**Paycor Stadium Southeast & Southwest VT Escalator Towers
Bid Package 2: Steel, Demo & Concrete
ITB#033-26
Addendum 3**

May 6, 2026

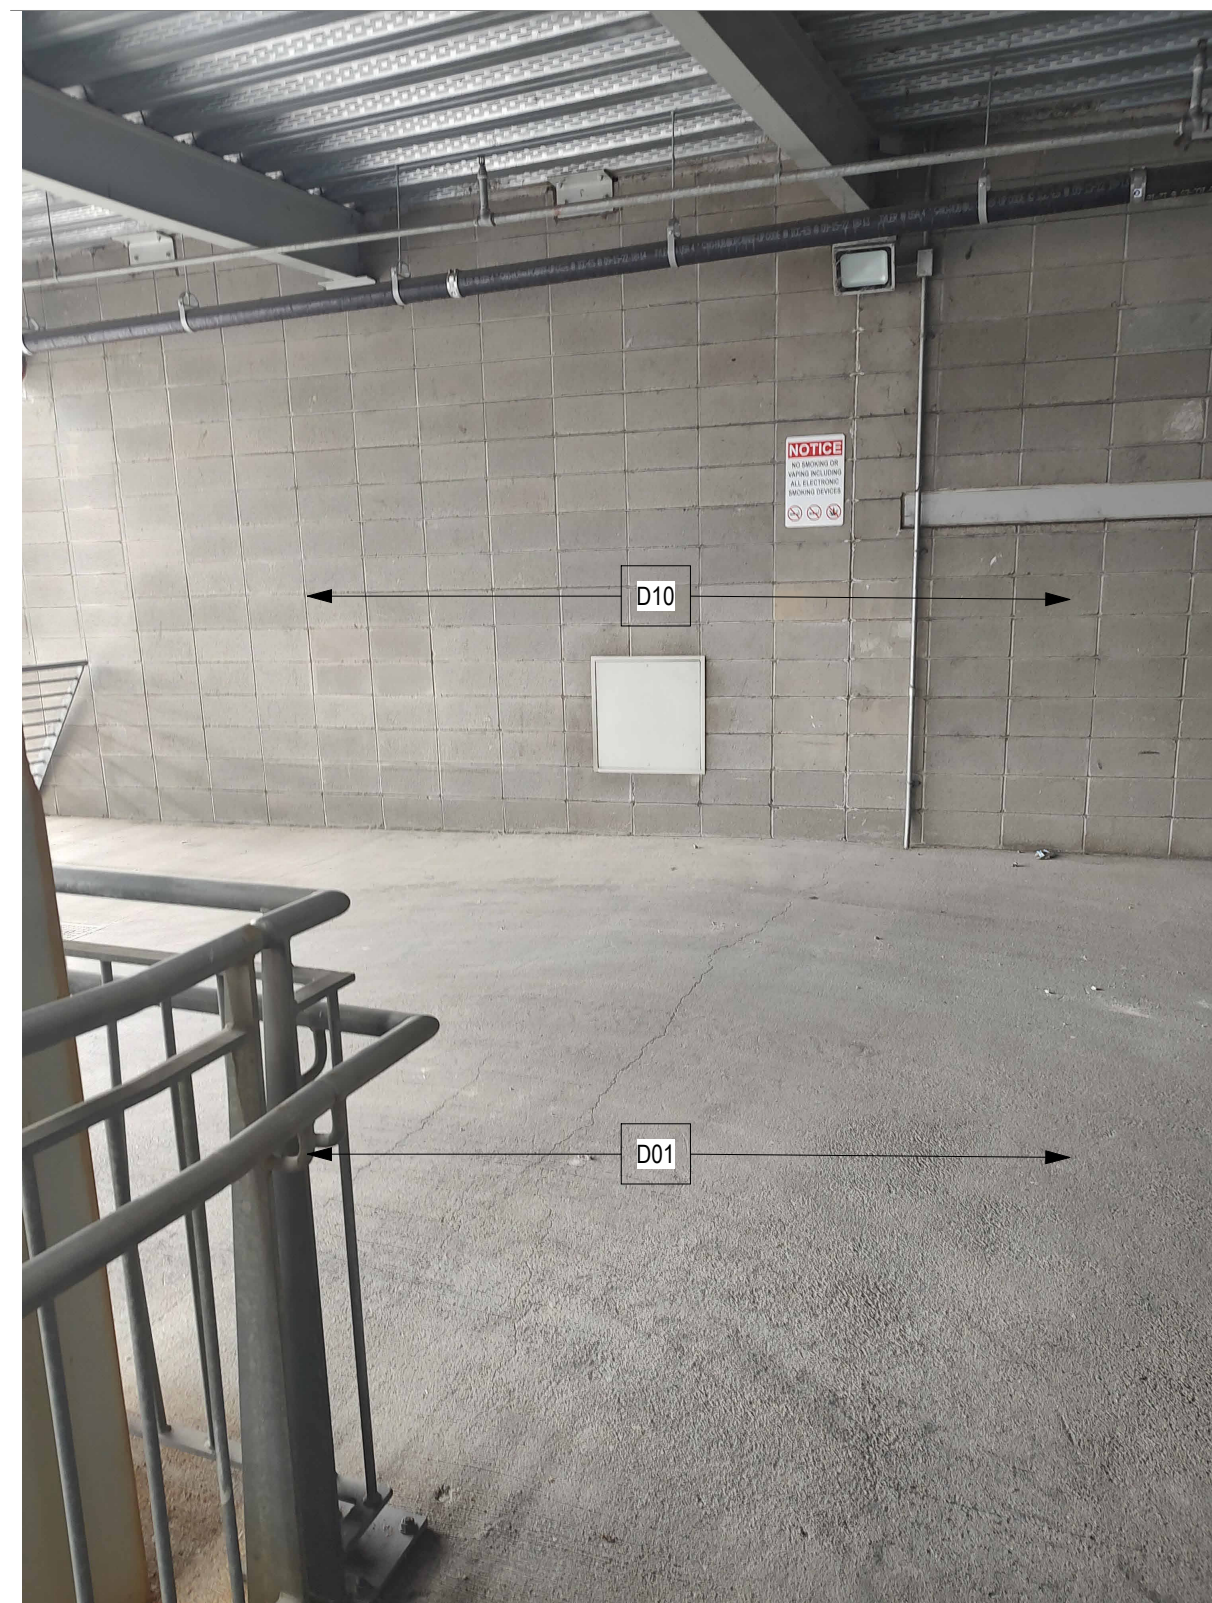
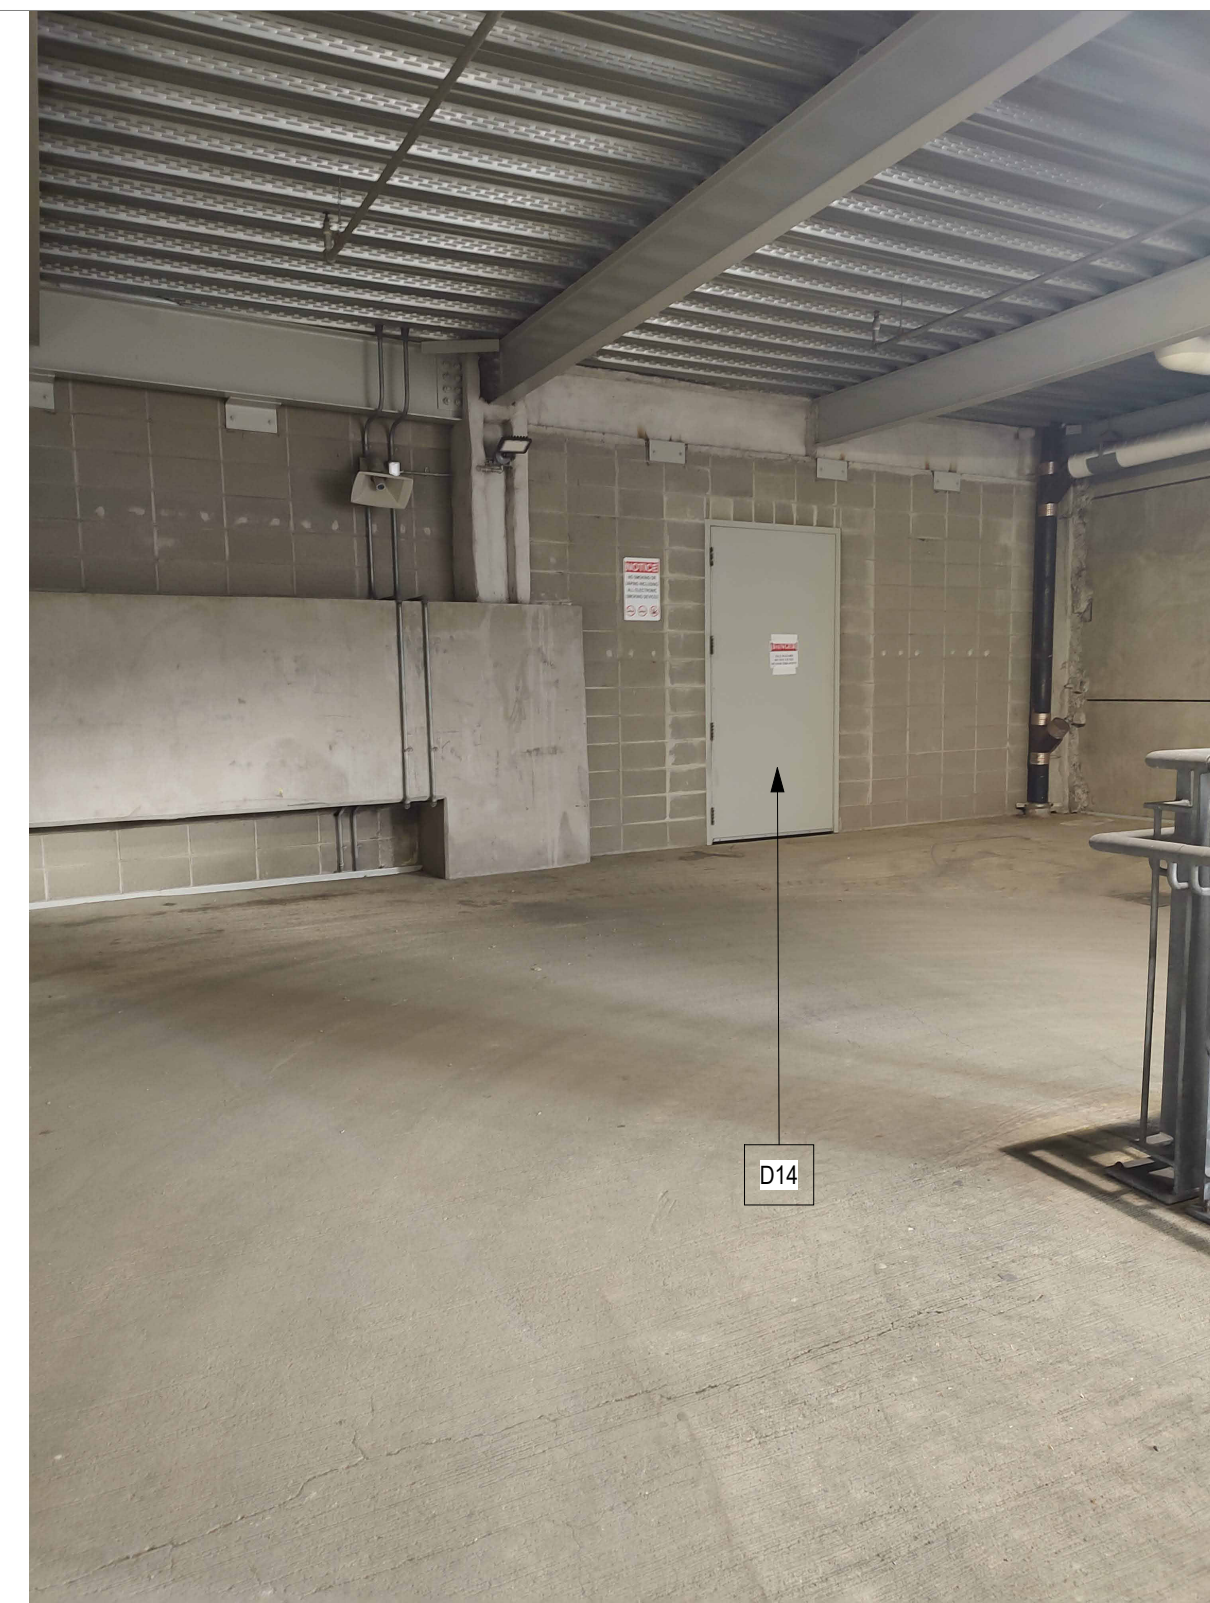
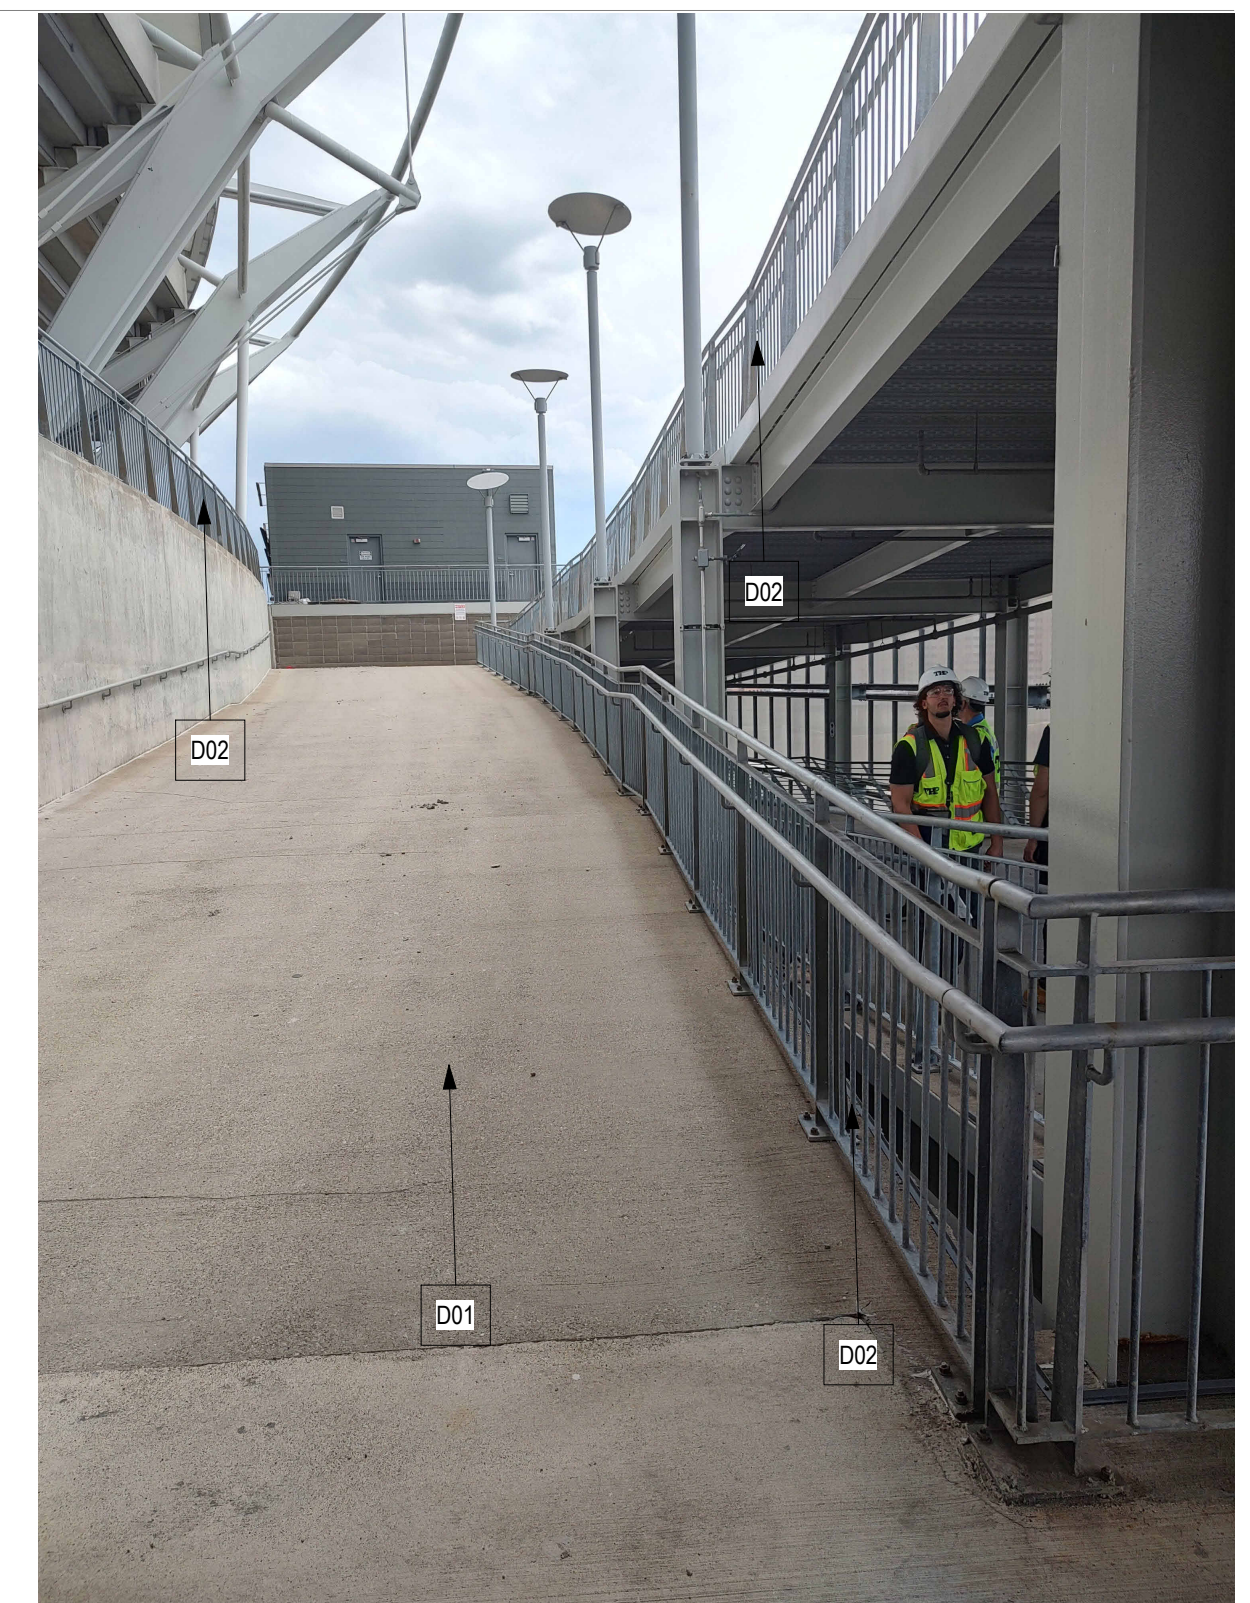
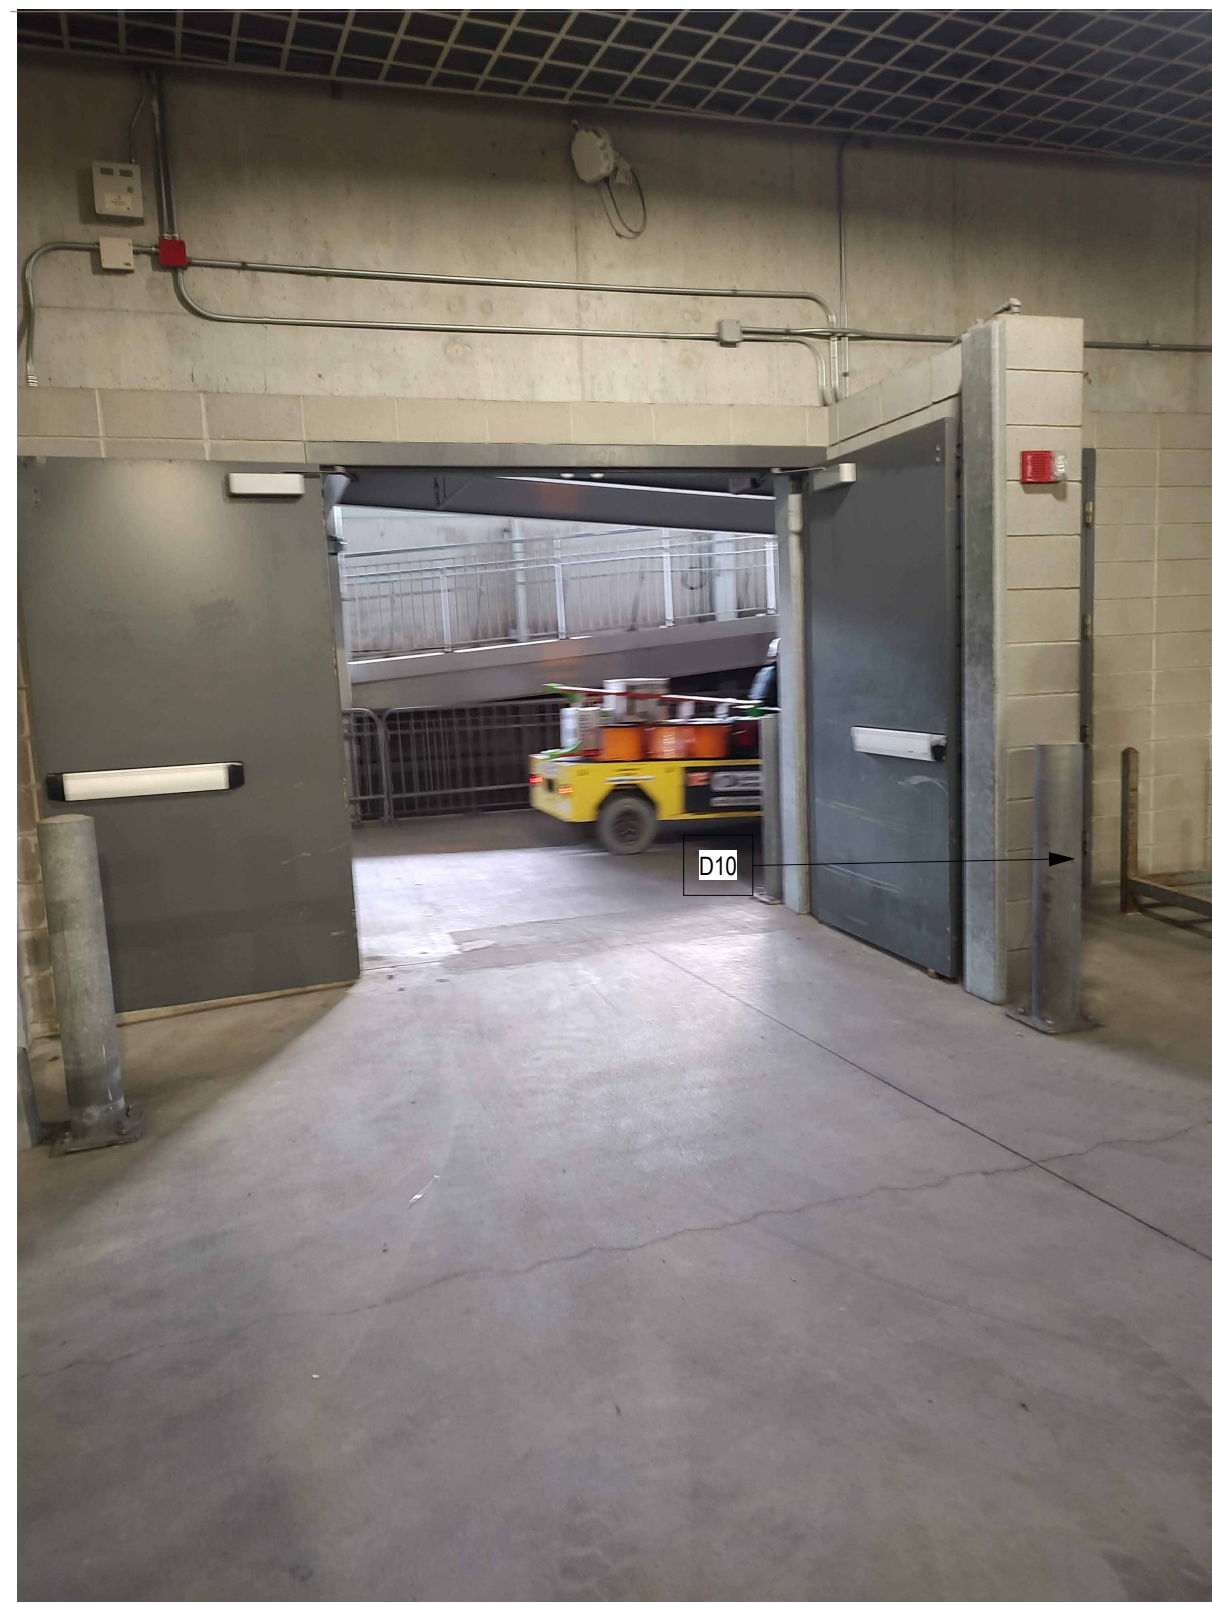
AD-101	New sheet with existing photos.
AD-103.4	Sector 4 – Level 400, 500 North wall to remain with limited demolition to remove existing Club stair.
AD-104.4	Sector 4 – Level 600 North wall to remain
AD-211.4	Sector 4 – Demolition Section & Elevation North wall to remain with limited demolition to remove existing Club stair.
S-103	Refer to sheet for clouded revisions
	Framing revisions
	S-104
	Refer to sheet for clouded revisions
	Framing revisions
S-105	Refer to sheet for clouded revisions
	Framing revisions
	Added section cuts
S-106	Refer to sheet for clouded revisions
	Framing revisions
S-108
